Charlotte Historic District Commission - Case 2016-085
HISTORIC DISTRICT: WESLEY HEIGHTS

April 29, 2016

**Grandin Heights Community
F.K.A. Grandin Road / W. 4th Street
Townhomes**

1471
March 30, 2015 - HDC Revised Submittal
SHEET NAME
Wall Section and Window Details

2 Grandin Heights Townhomes - Proposed Third Floor Soffit Detail
1 1/2" = 1'-0"

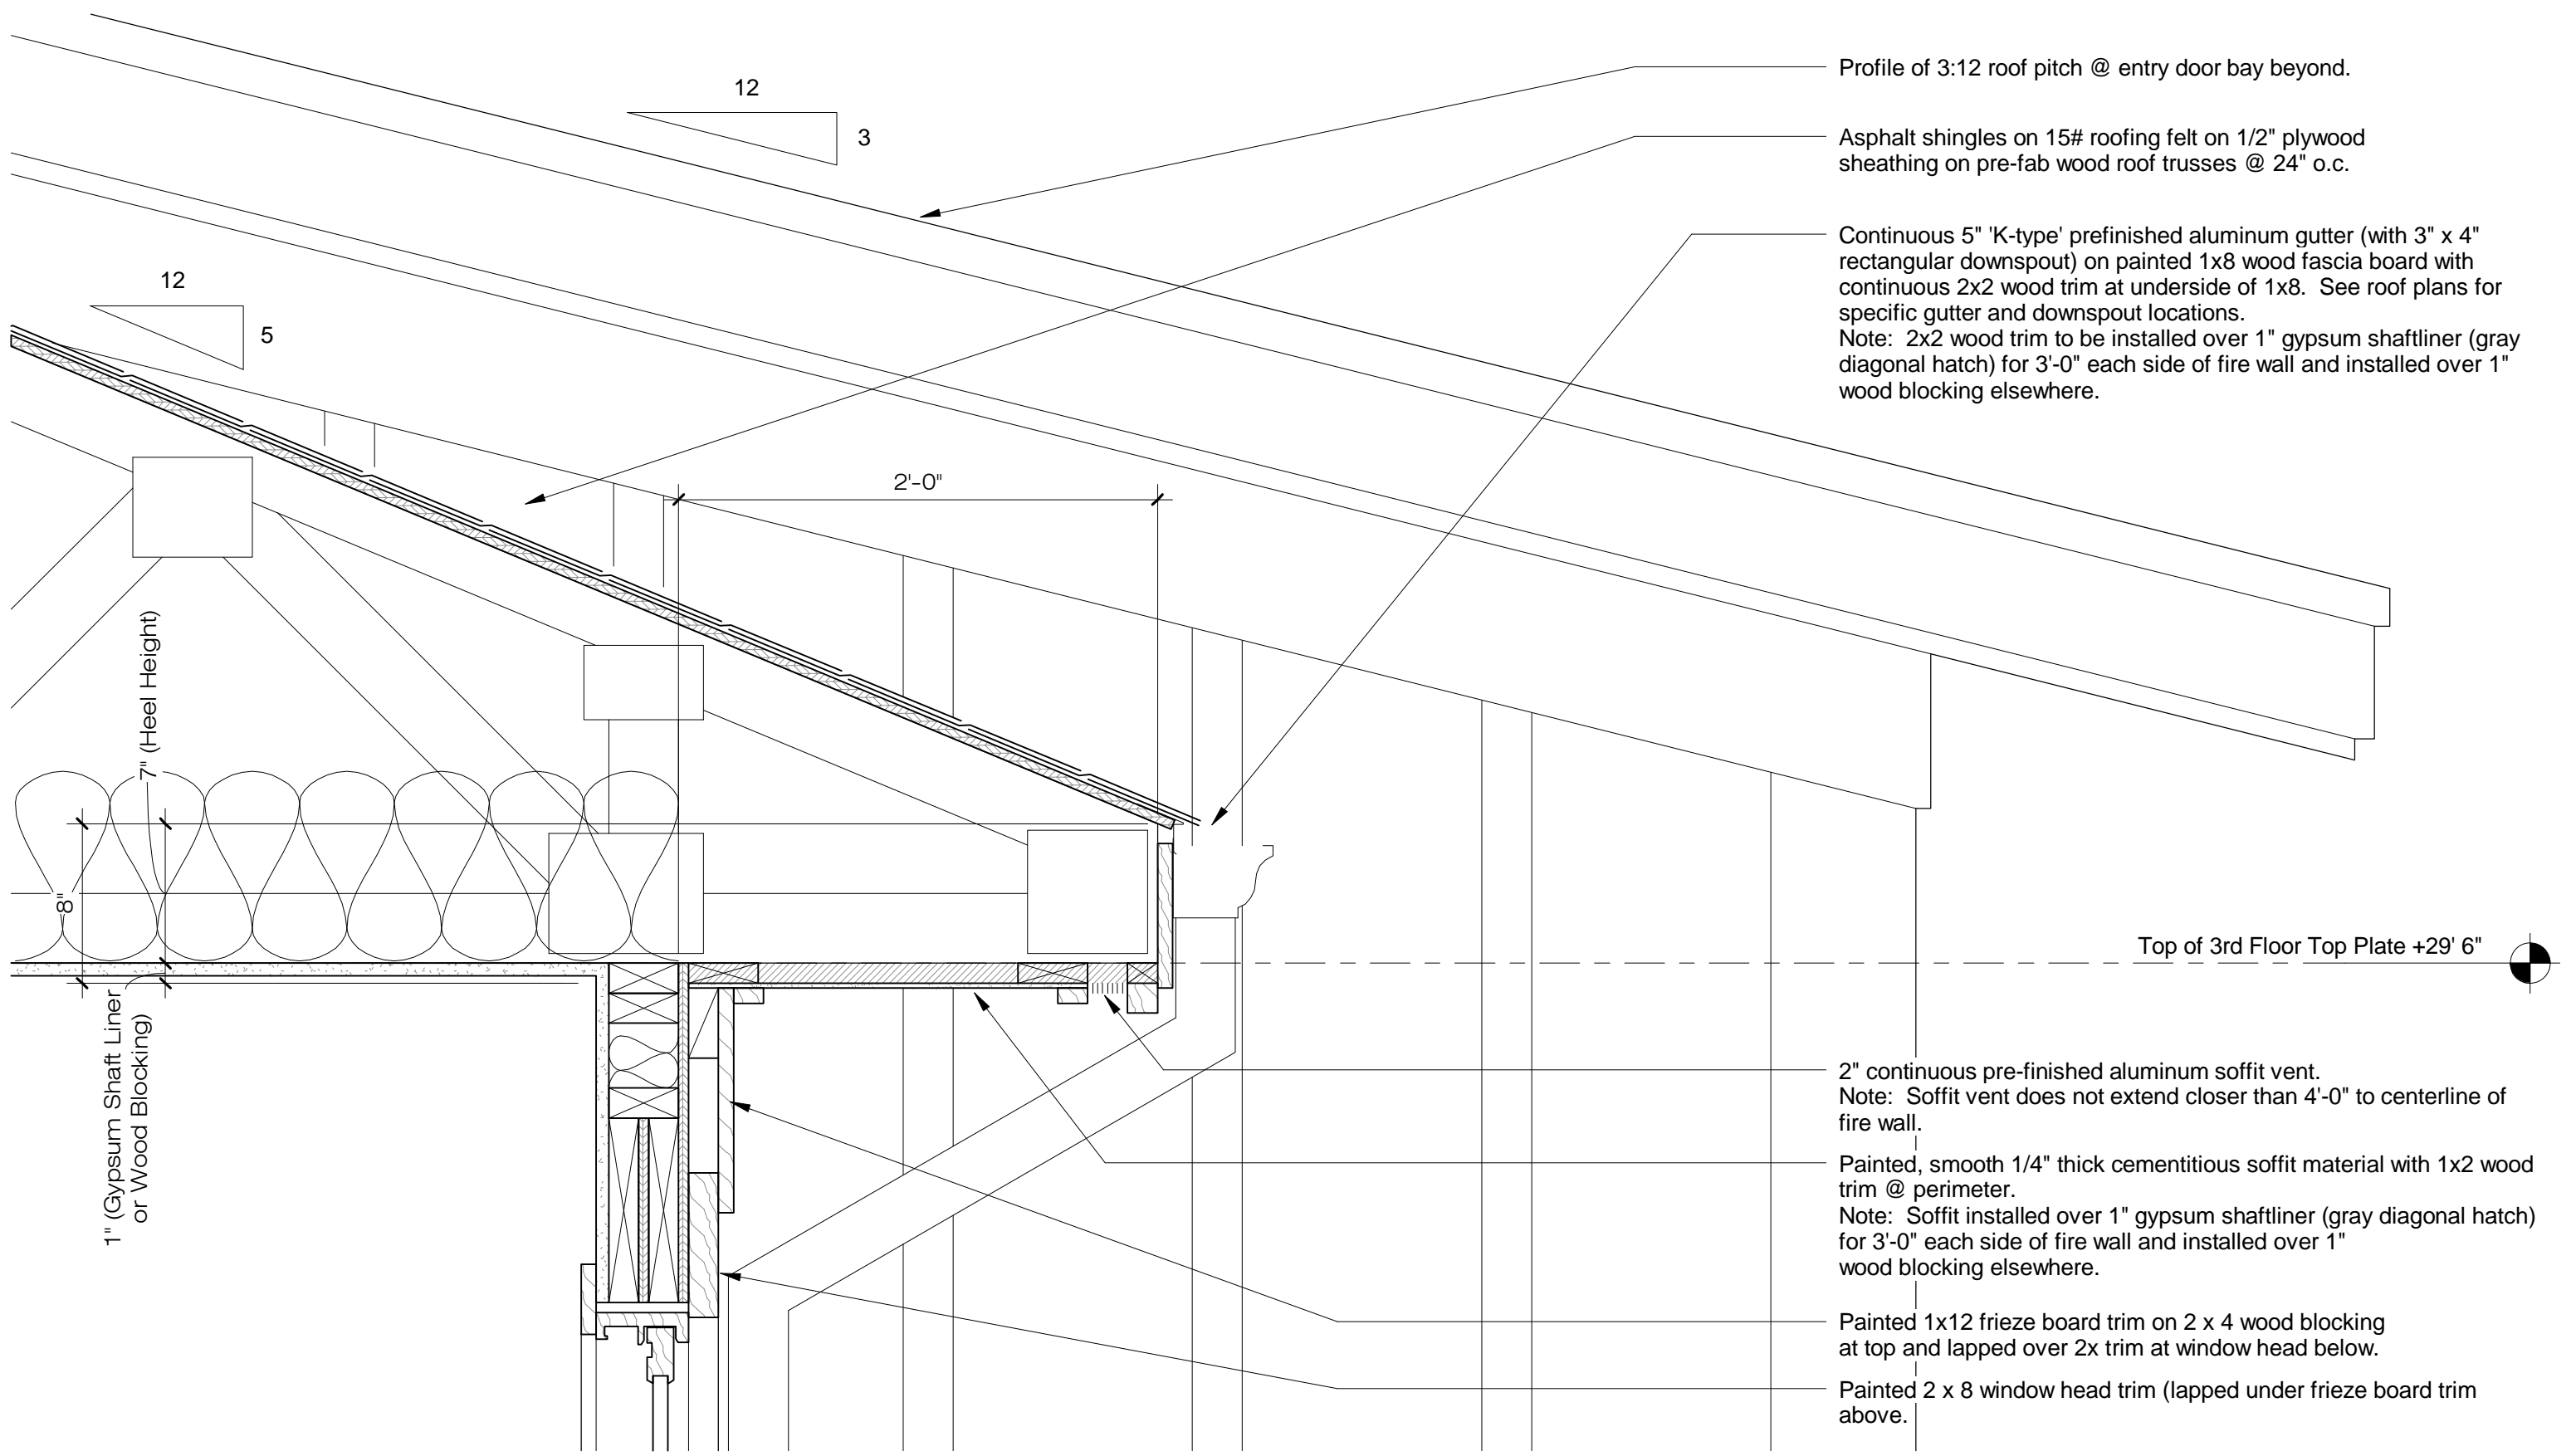
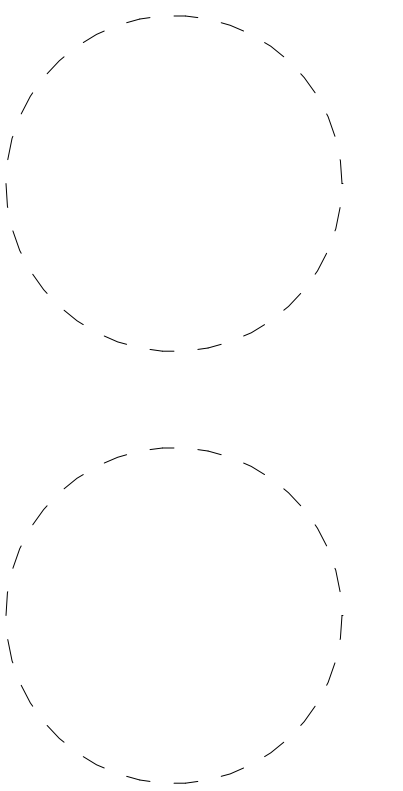
2" continuous pre-finished aluminum soffit vent.
Note: Soffit vent does not extend closer than 4'-0" to centerline of fire wall.

Painted, smooth 1/4" thick cementitious soffit material with 1x2 wood trim @ perimeter.
Note: Soffit installed over 1" gypsum shaftliner (gray diagonal hatch) for 3'-0" each side of fire wall and installed over 1" wood blocking elsewhere.

1 Wall Section @ Typical Living Room / Master Bedroom
1/2" = 1'-0"

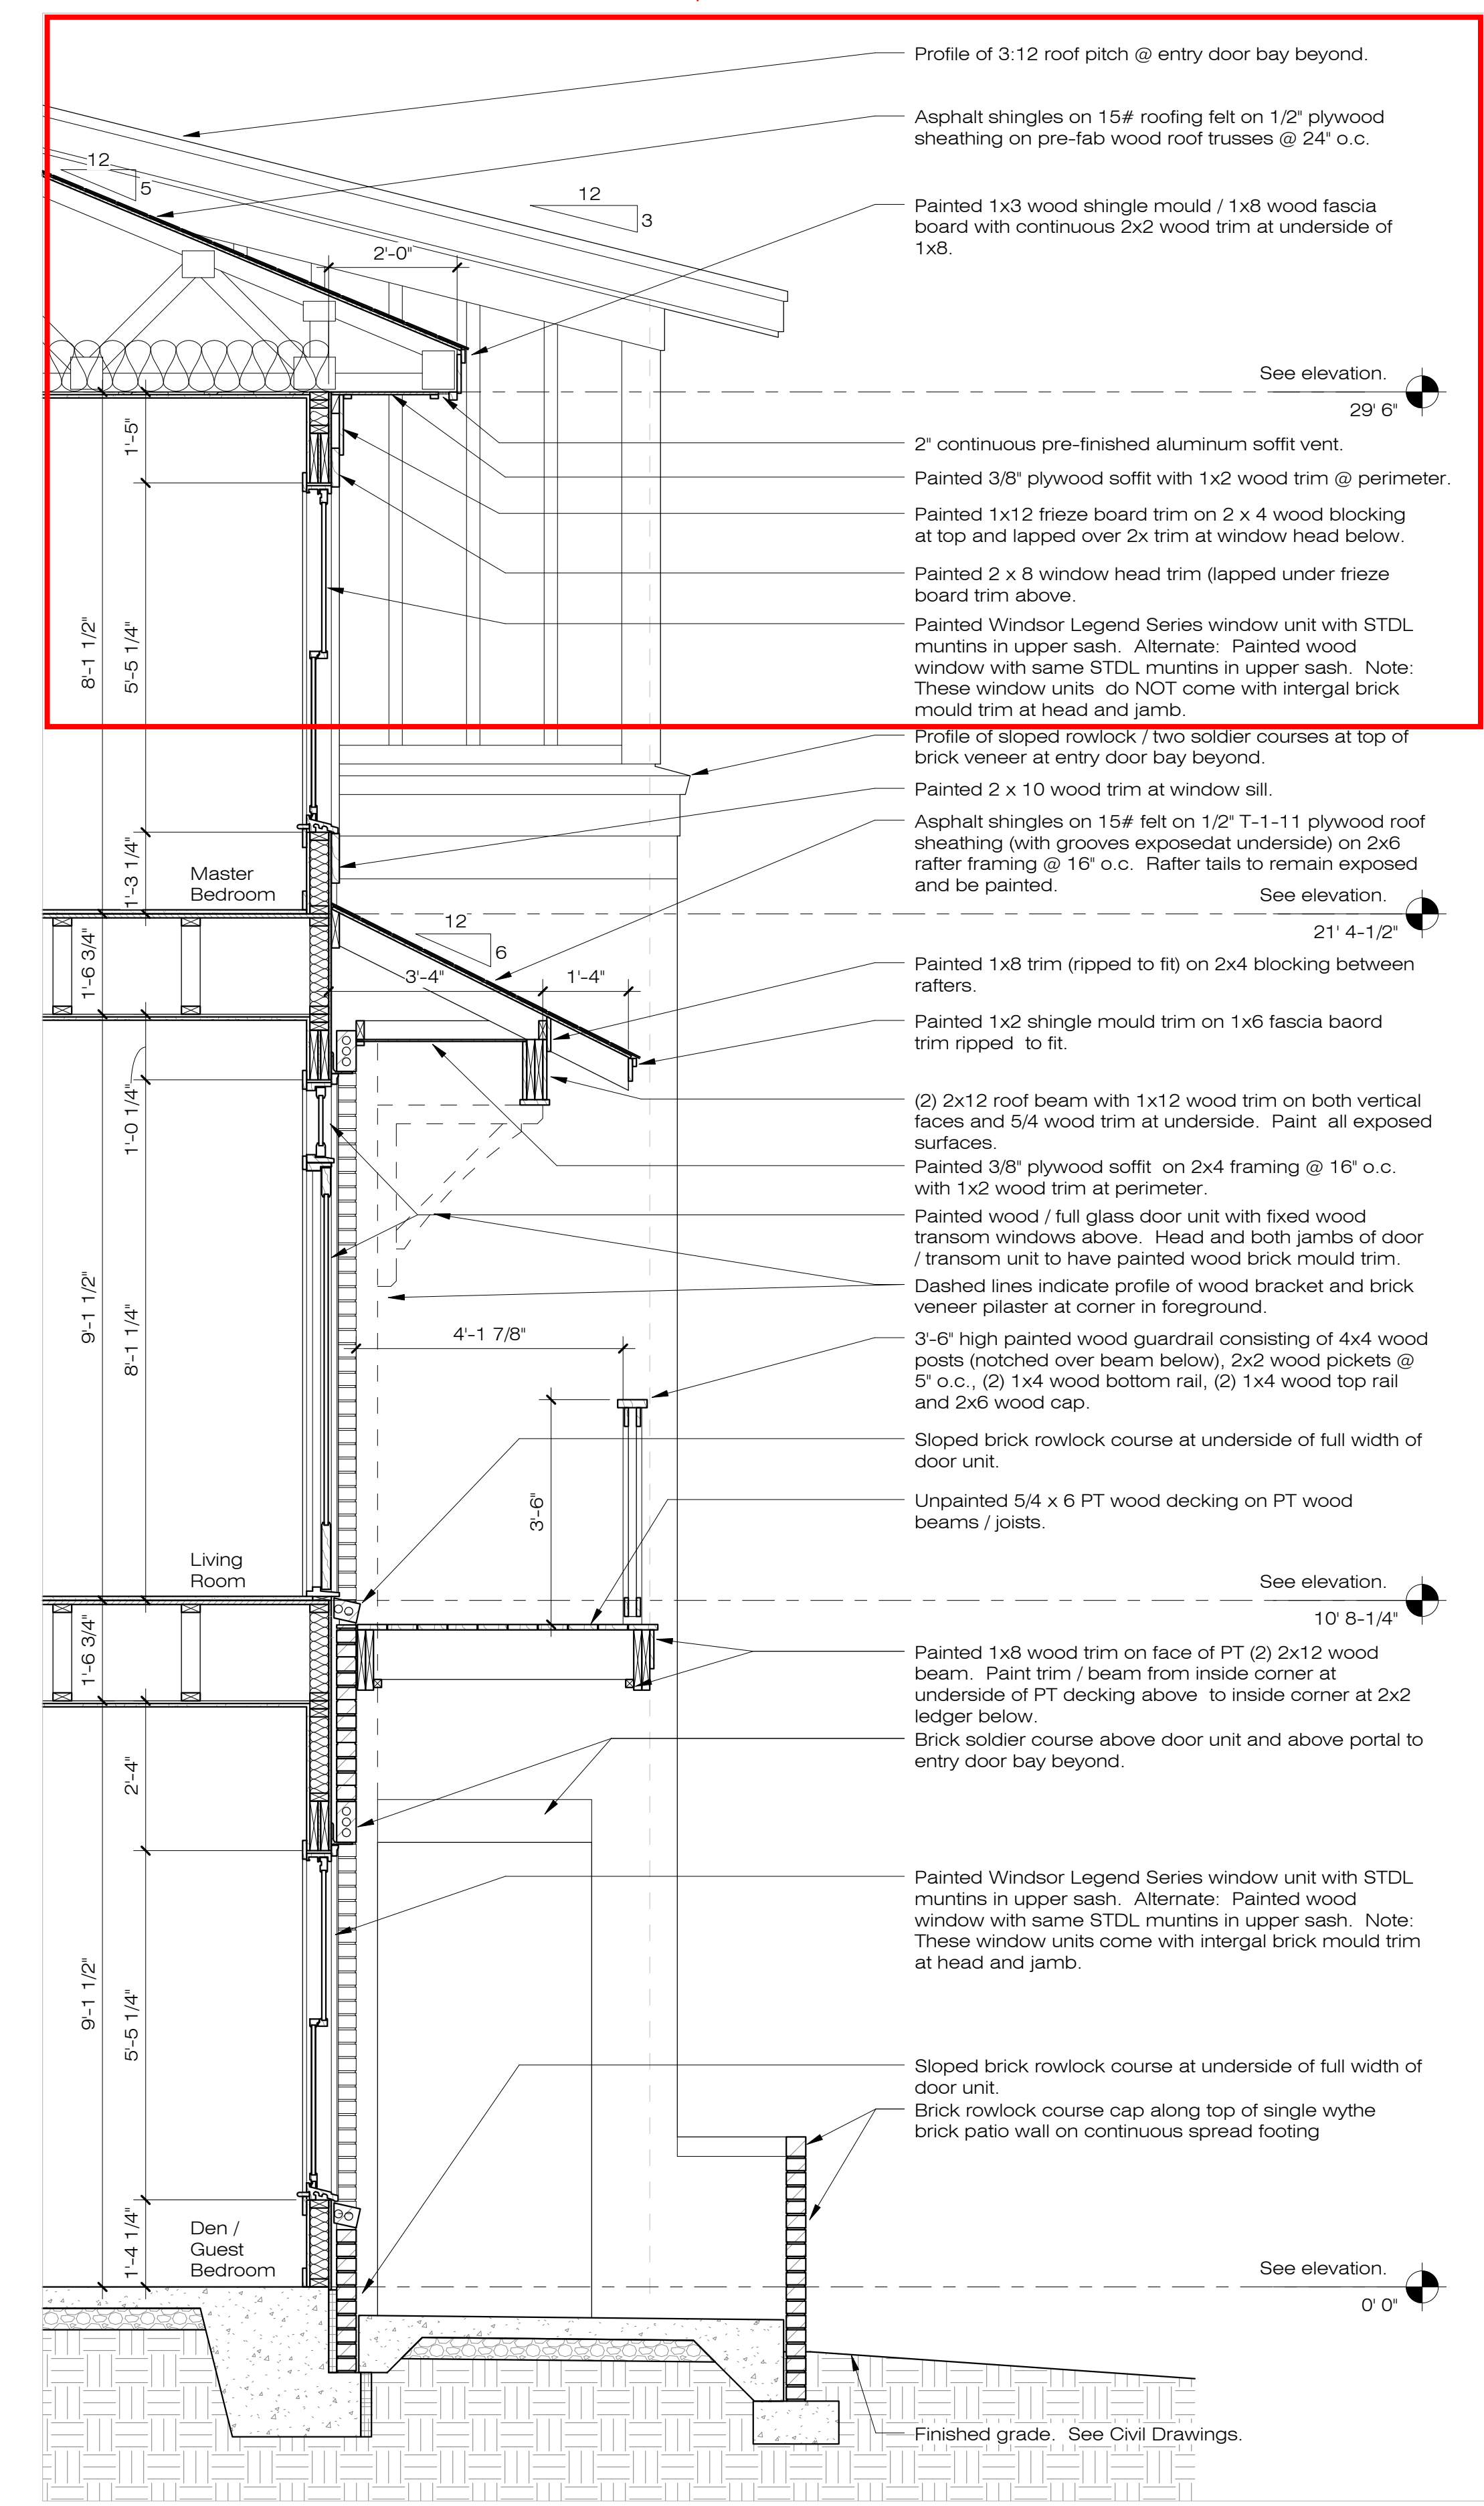
Attached Detail #1 (11" x 17" format) represents an enlarged view of this section of the approved wall section. Attached Detail #2 (also 11" x 17" format) represents the proposed new detail at this same location incorporating the non-combustible soffit material required by the NC Residential Code to minimize the risk of fire by-passing the 2-hour fire walls separating adjacent units.
